**CITY OF LOUISVILLE
STARK COUNTY, OHIO**

METZGER PARK BASEBALL & SOFTBALL FIELDS

ADDENDUM #4

September 25, 2023

PITCHER MOUND DETAIL

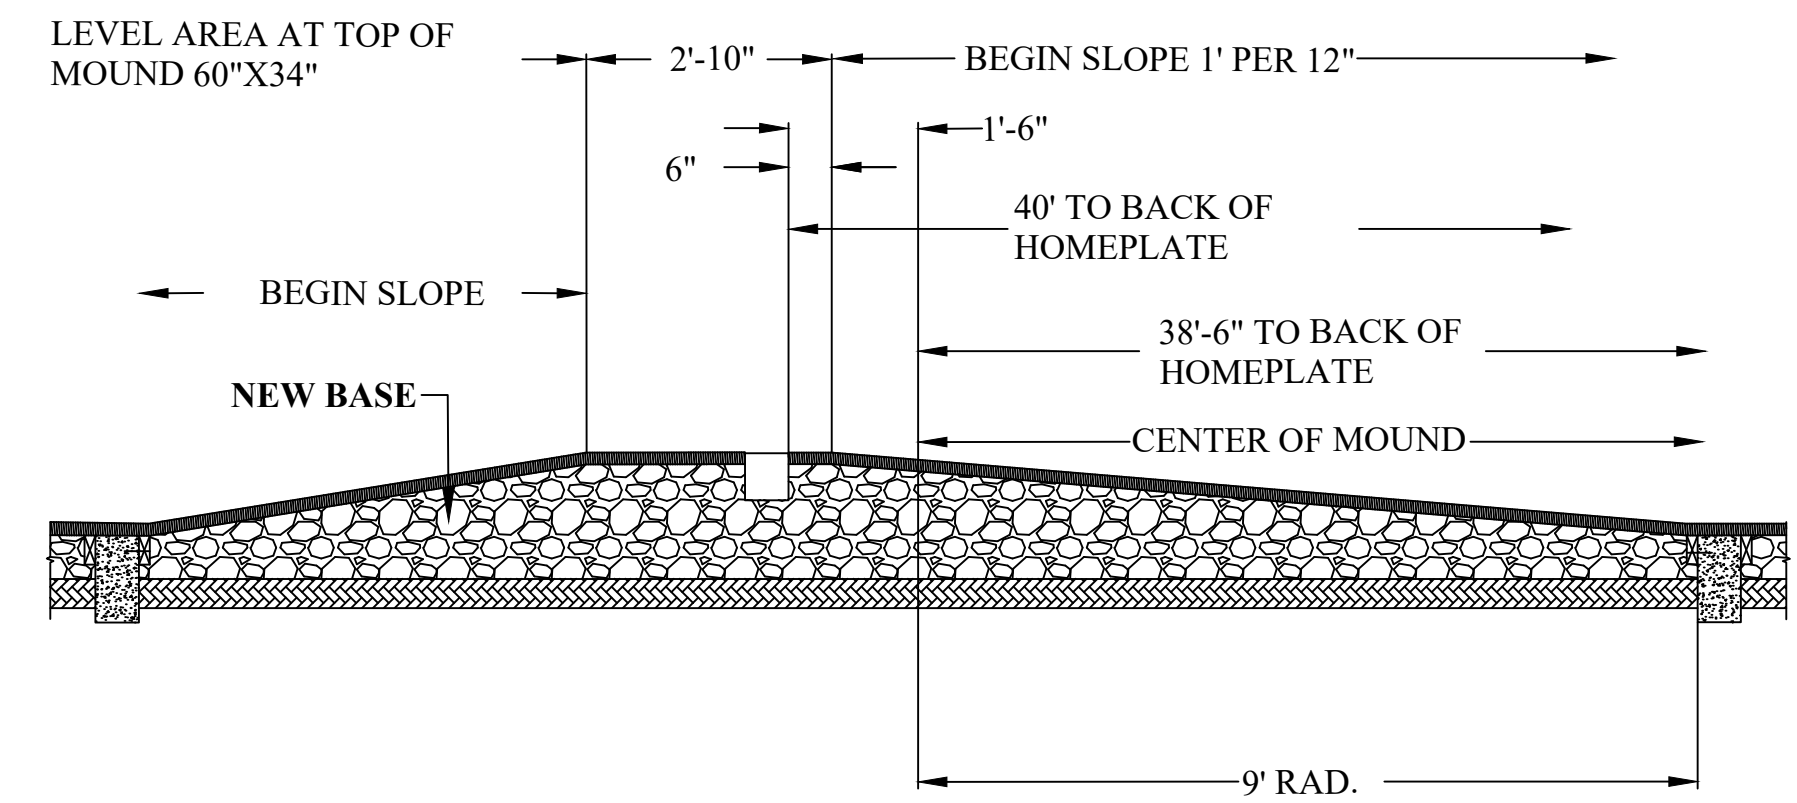
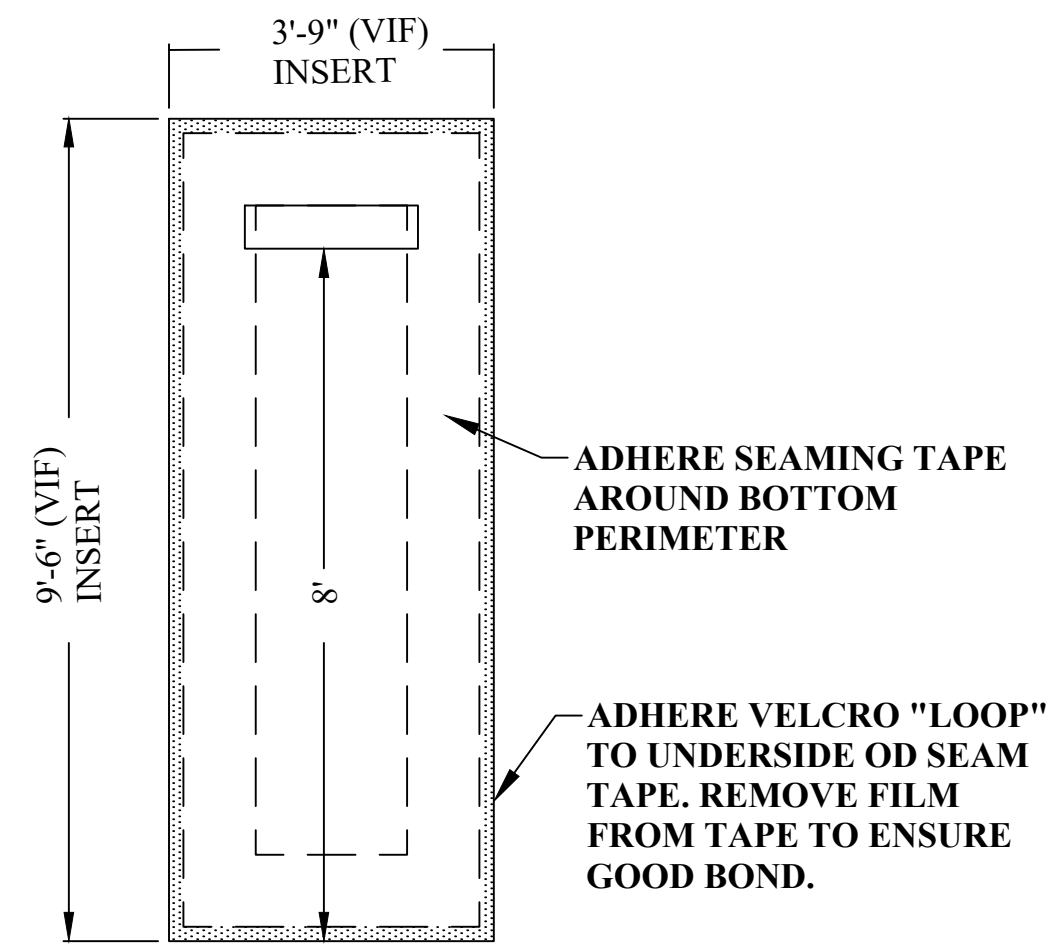
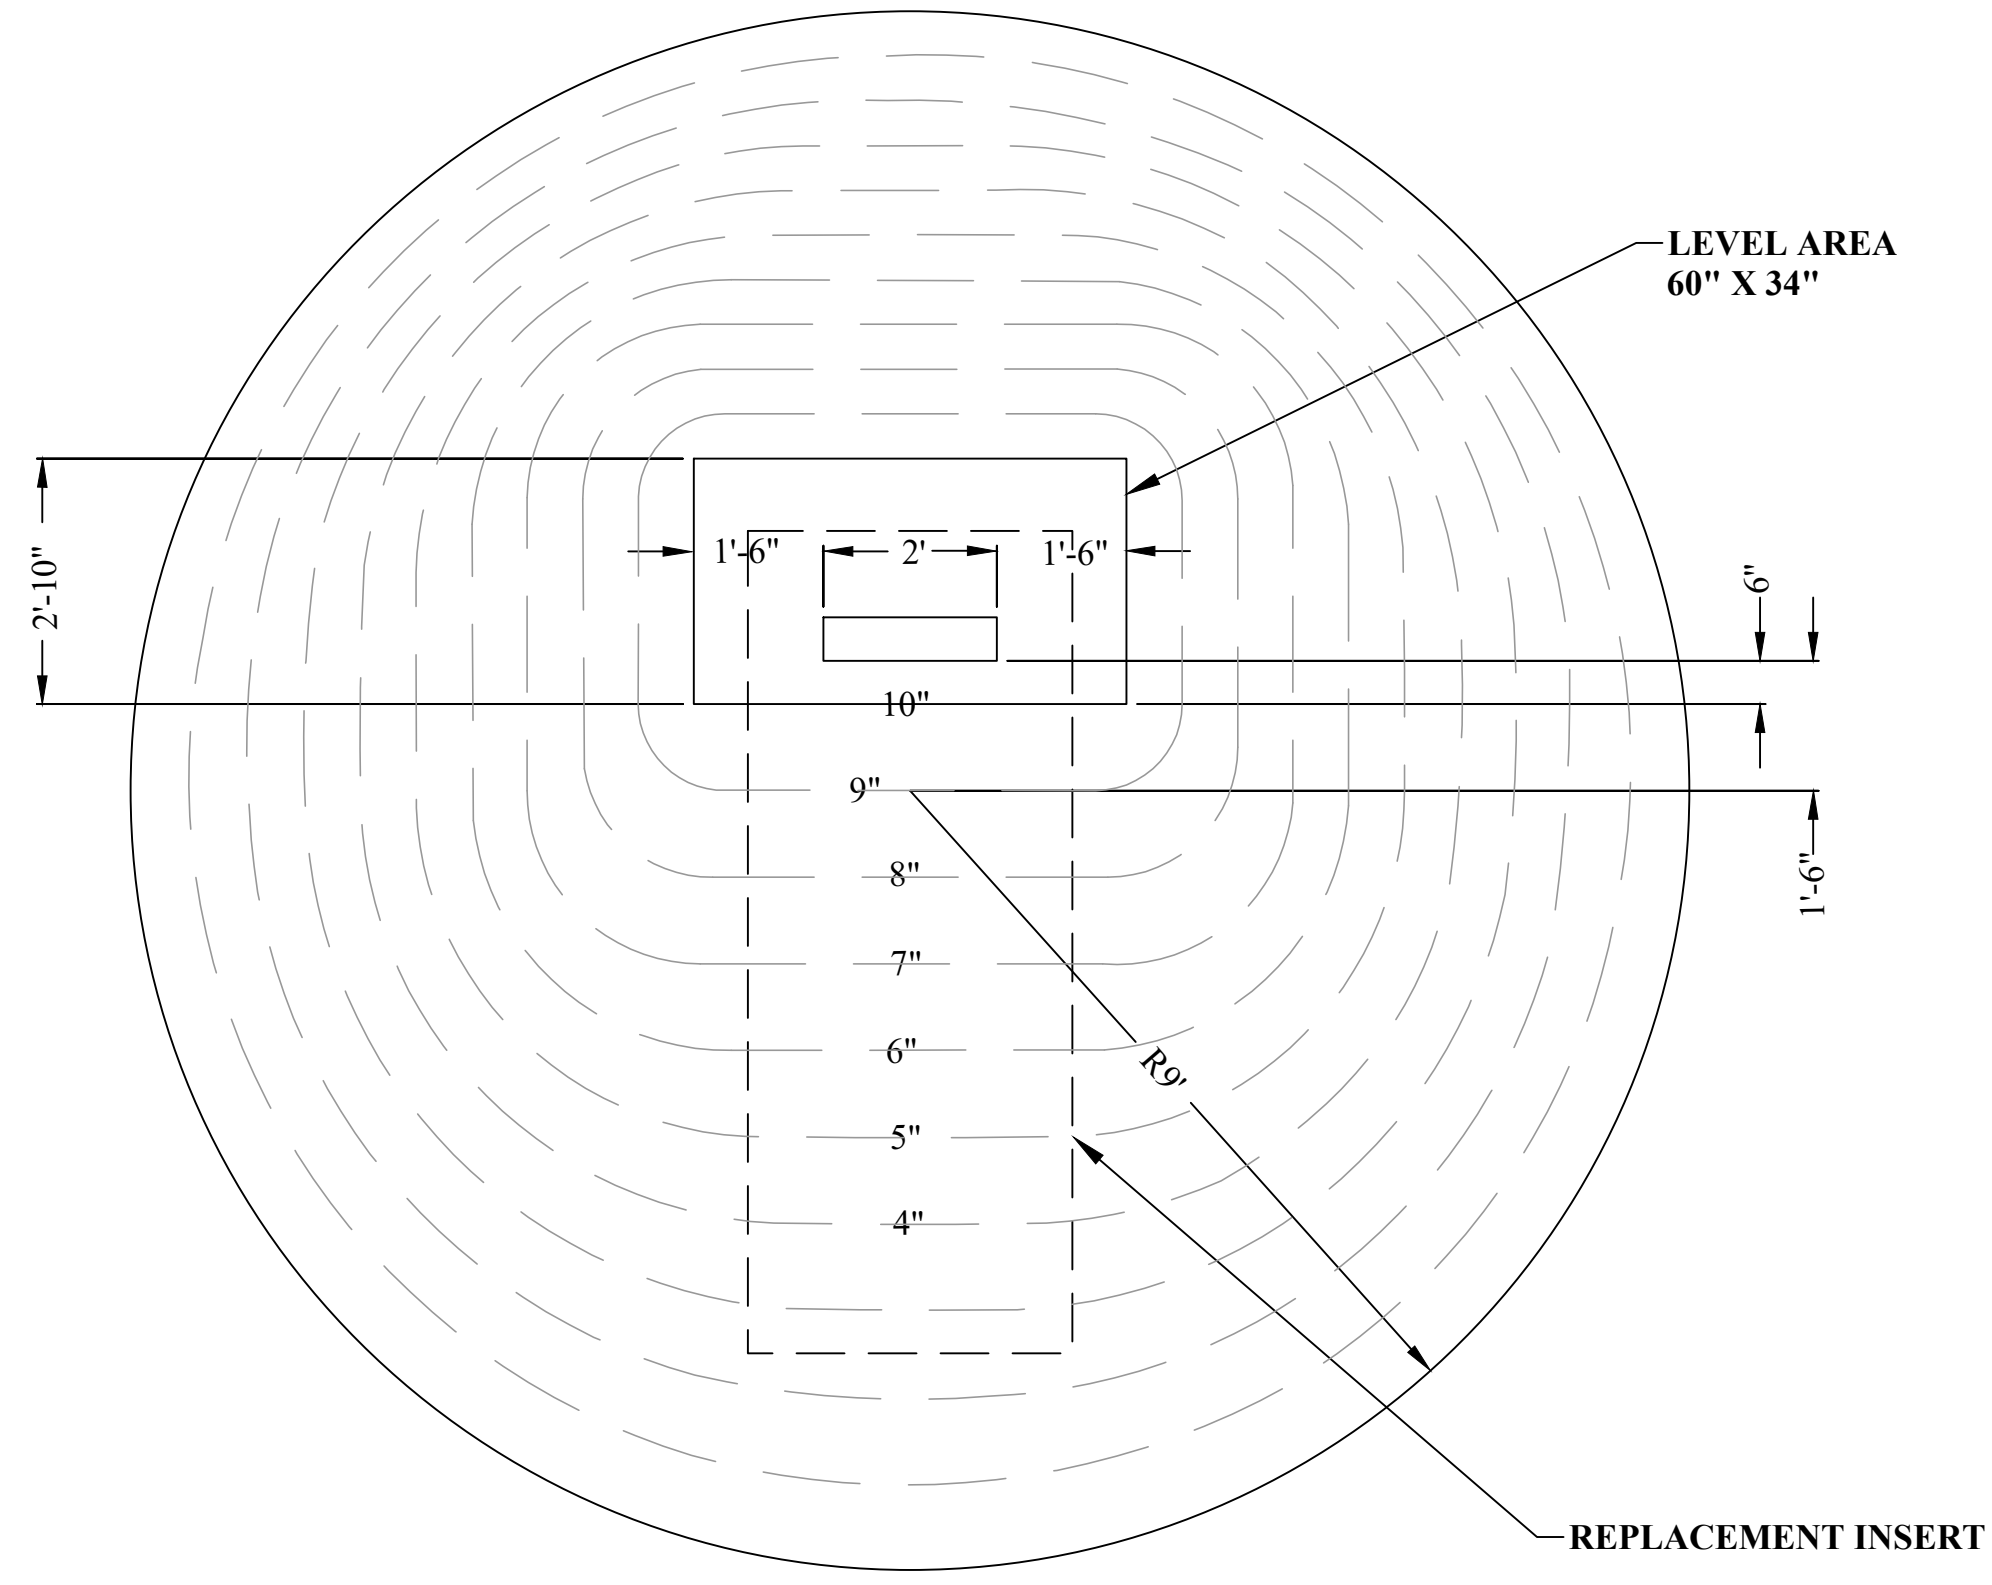
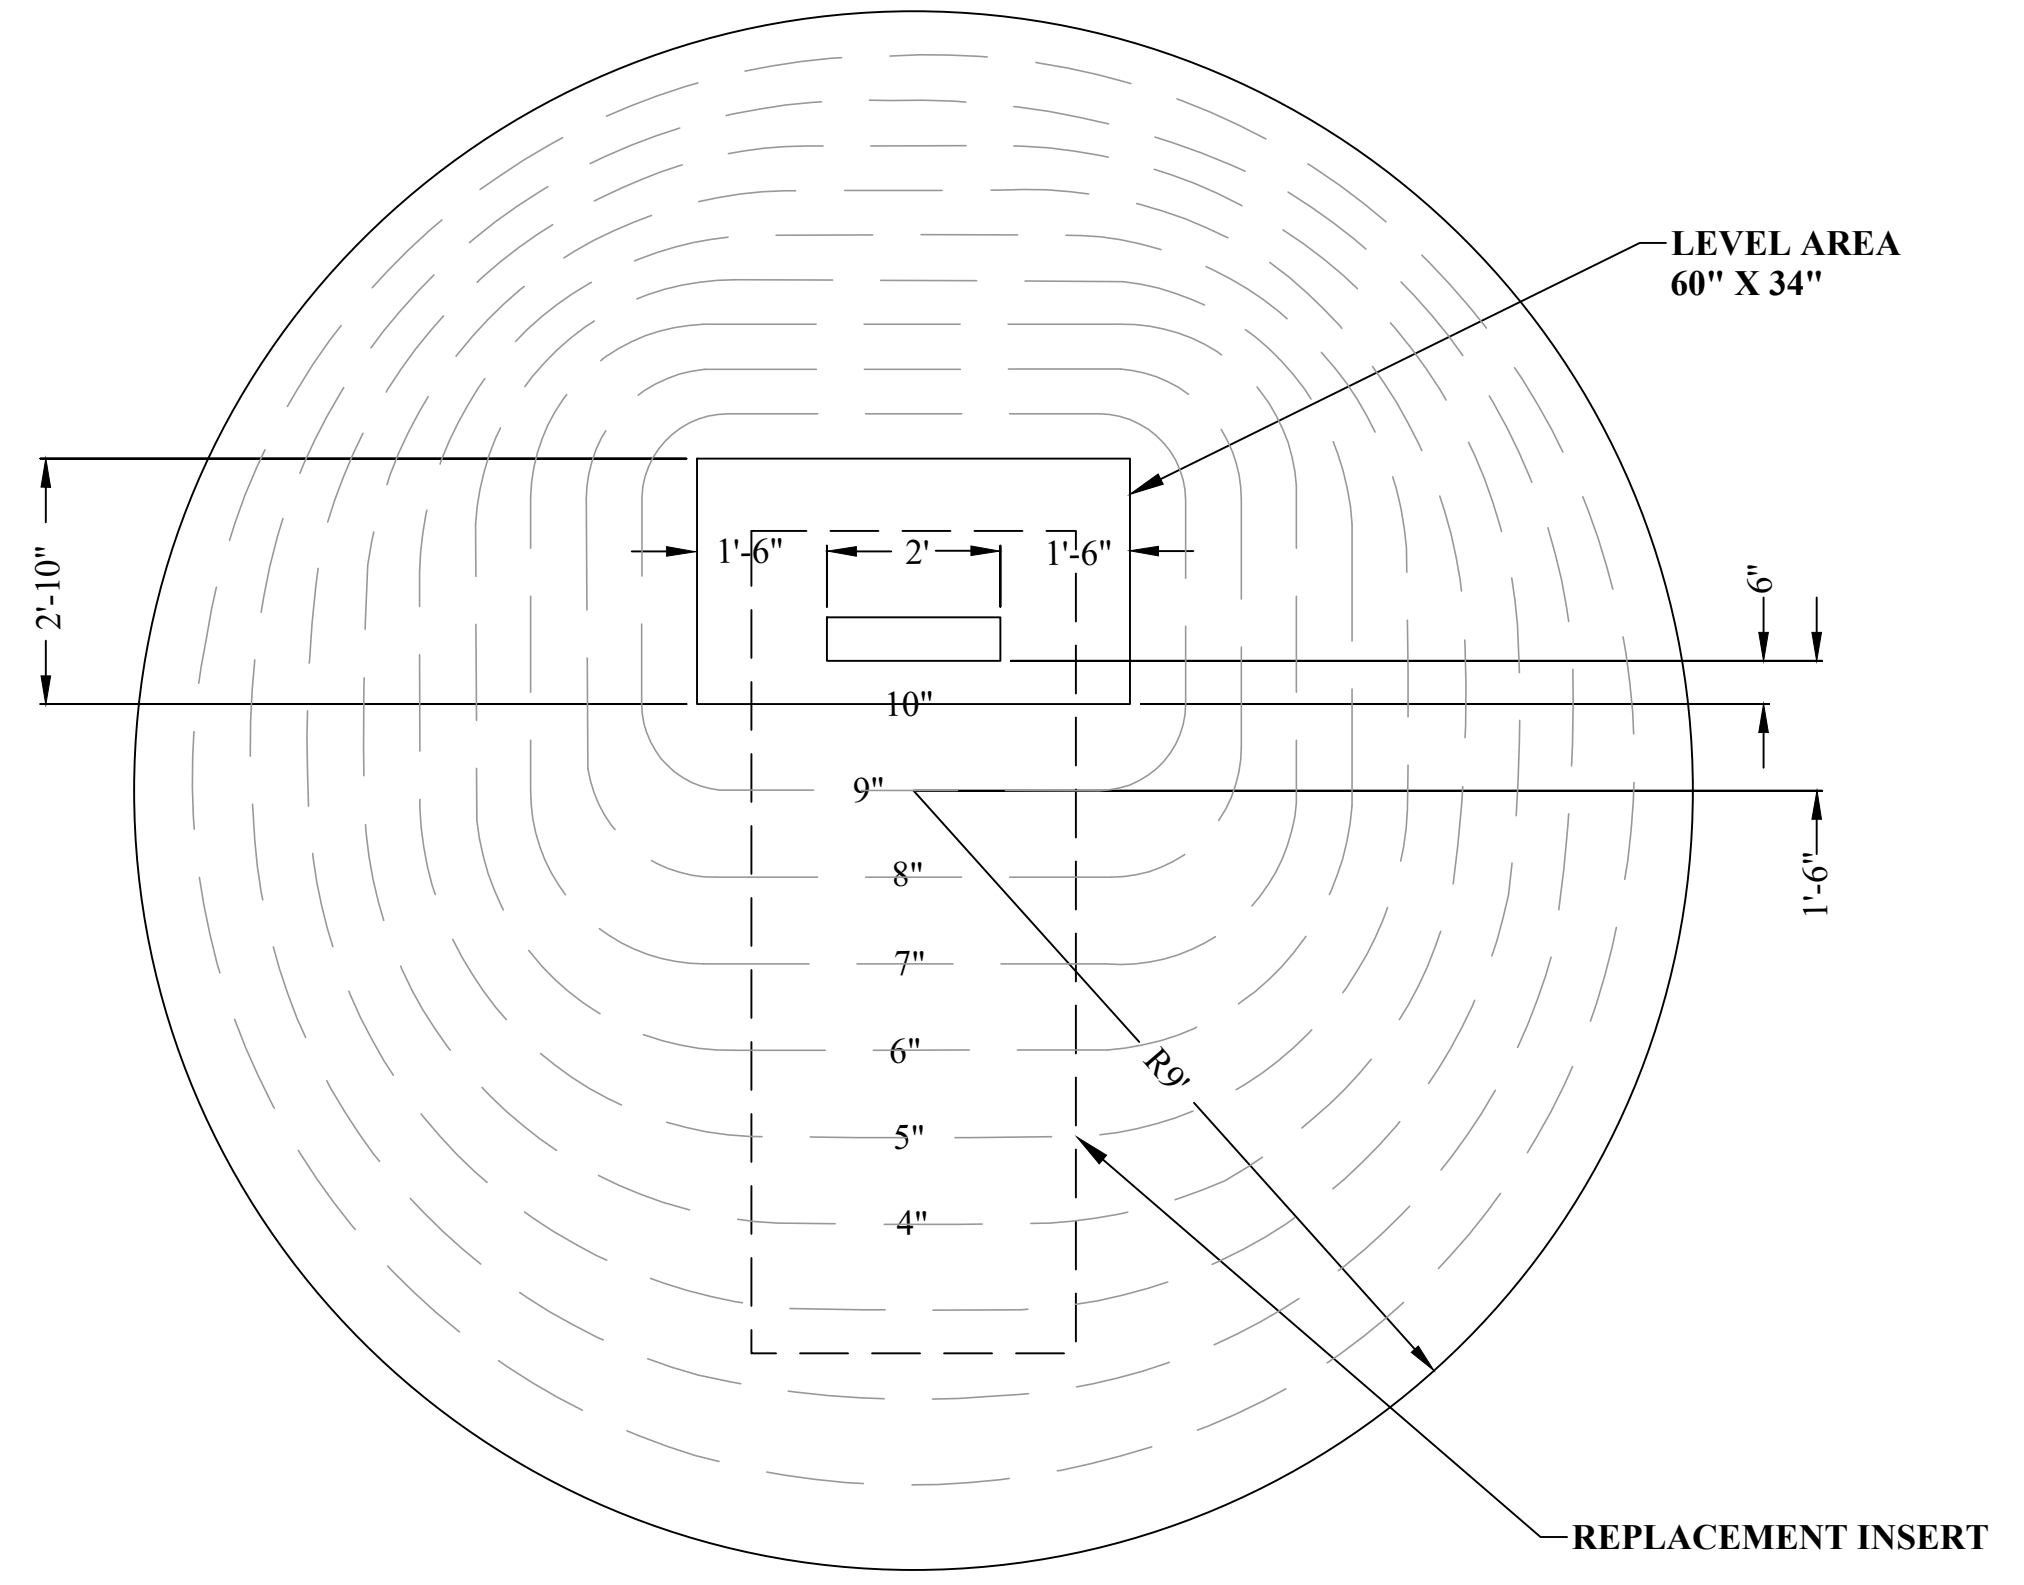
21. Please provide specifications for the material to be used as the replacement insert for the Pitcher's Mound as shown on Sheet 33.

The replacement insert is to be from True Pitch, The Perfect Mound, Beacon Athletics, or approved equal.
